5.0 Figure 4 Bicycle Parking

Government Architect NSW

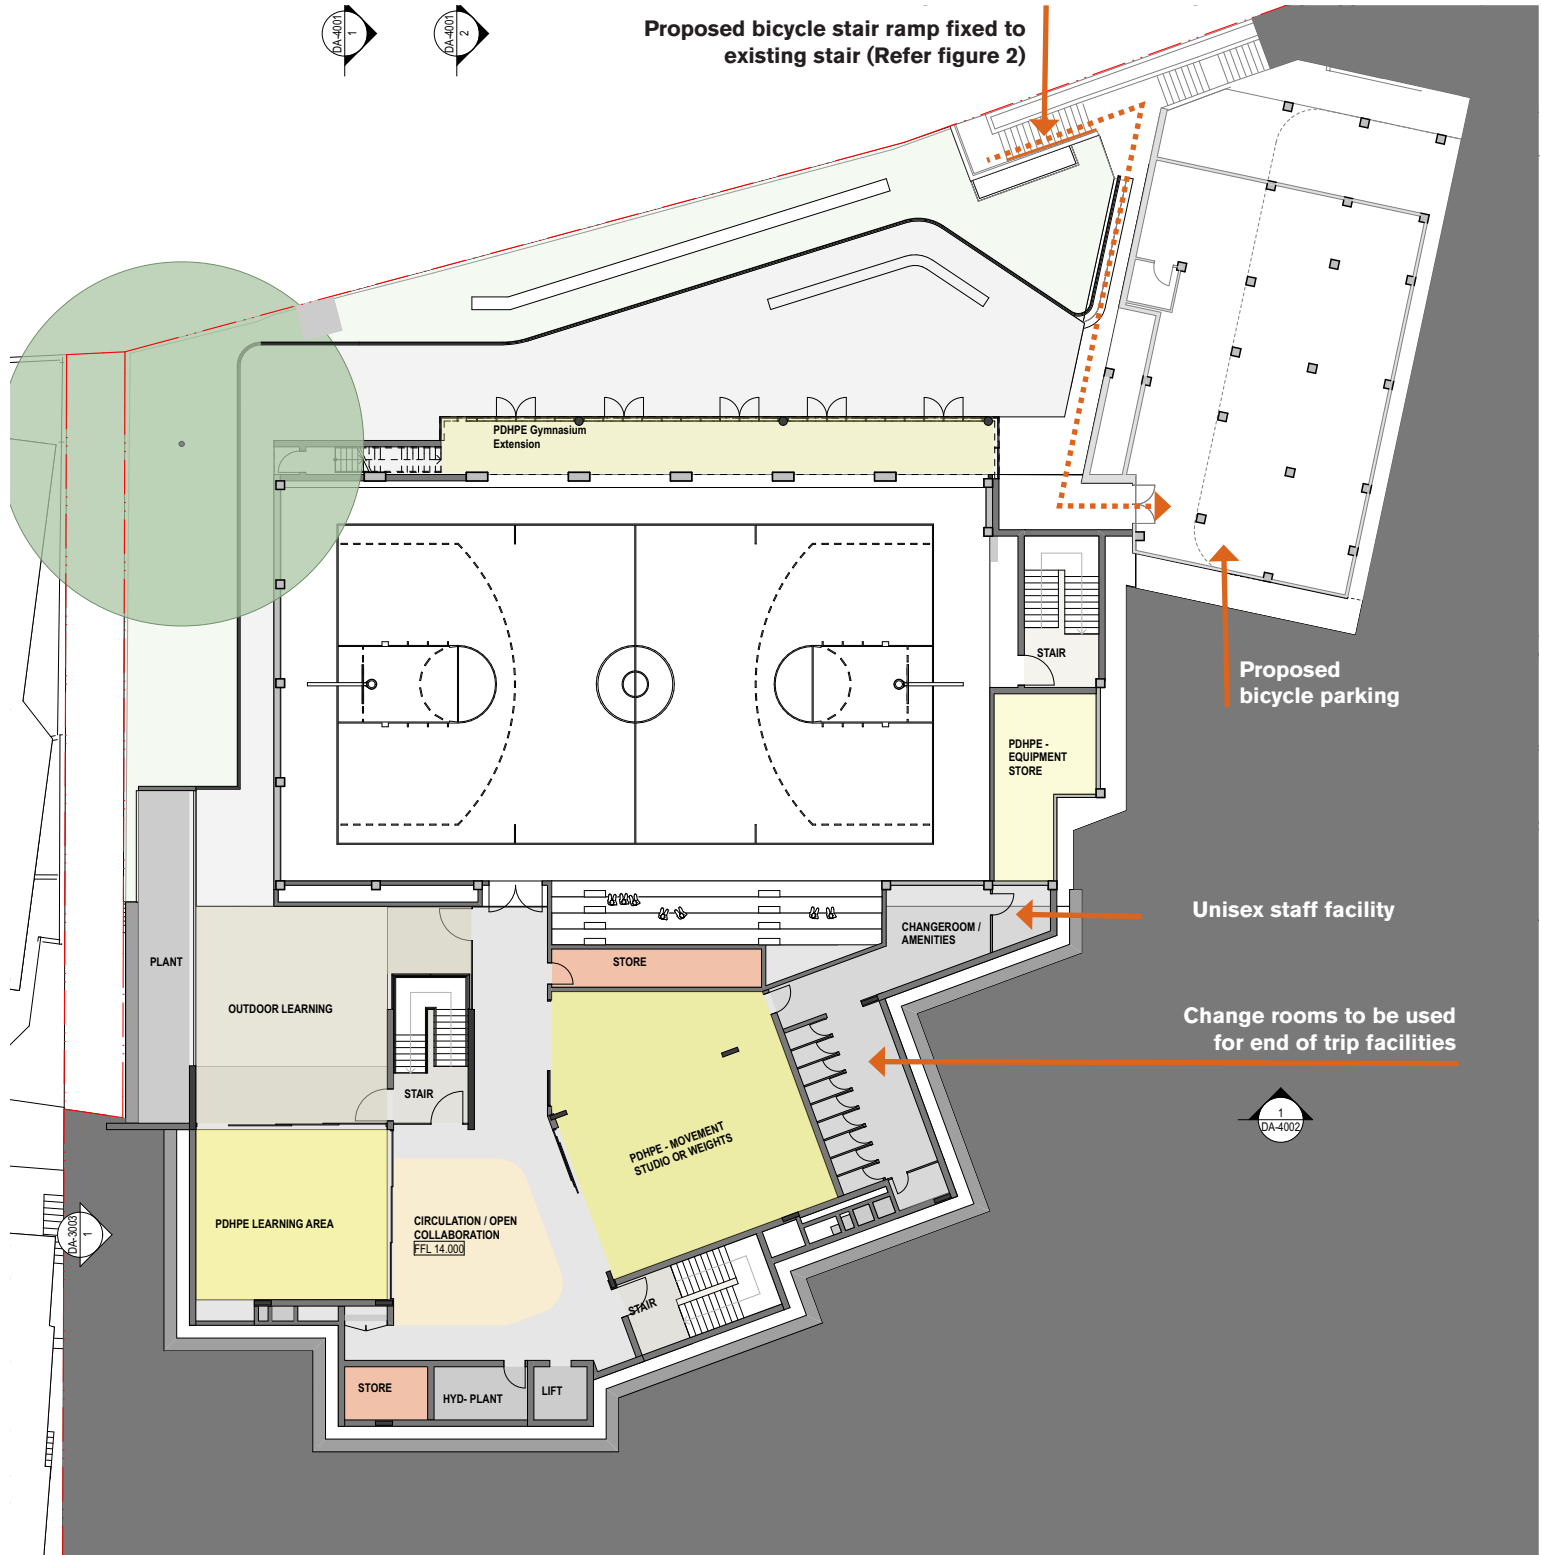
Comment :
No bicycle parking is provided. The transport and traffic survey showed that no students or staff arrive at school by bicycle, and that the school is very well serviced by public transport. However due to the density of the surrounding residential area street parking is in high demand and therefore all car trips and parking to the school should be discouraged. Bicycle parking and end of trip facilities should be provided.

Response:
Approximately 20 bicycle parking spaces are able to be provided in the existing sports storage area on the lower ground level of Centenary Hall with the end of trip facilities within the adjacent Lower Ground level of the New Learning Hub. Access is able to be provided directly off Elamang Avenue via a stair ramp on the existing stairs.
